ATCB comment Answer:

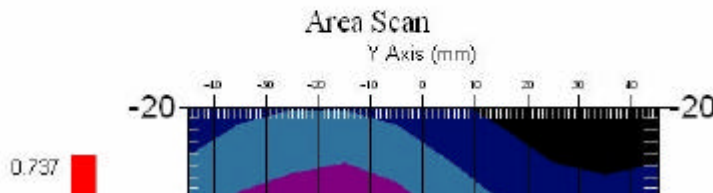
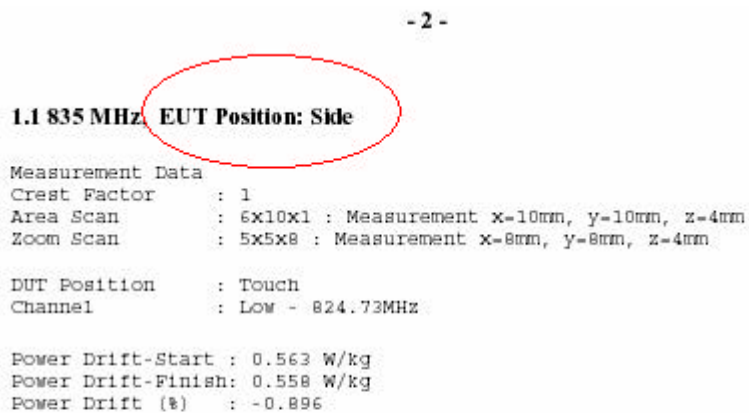
3.) Your "Internal Photograph" on page 4 is difficult to read. The antennas may be 20cm or more away from the end user (excluding hands, wrists, feet and ankles) if this notebook PC is placed on the lab. This would then not require a SAR test. Please review. Please remember to make all your photographs large enough and clear enough to clearly see all construction details.

[ANS: 2 more clear shots on eut-5 and eut-6 about the antennas location.](#)

[It needs SAR test because it distance between antenna to end user is less than 20cm.](#)
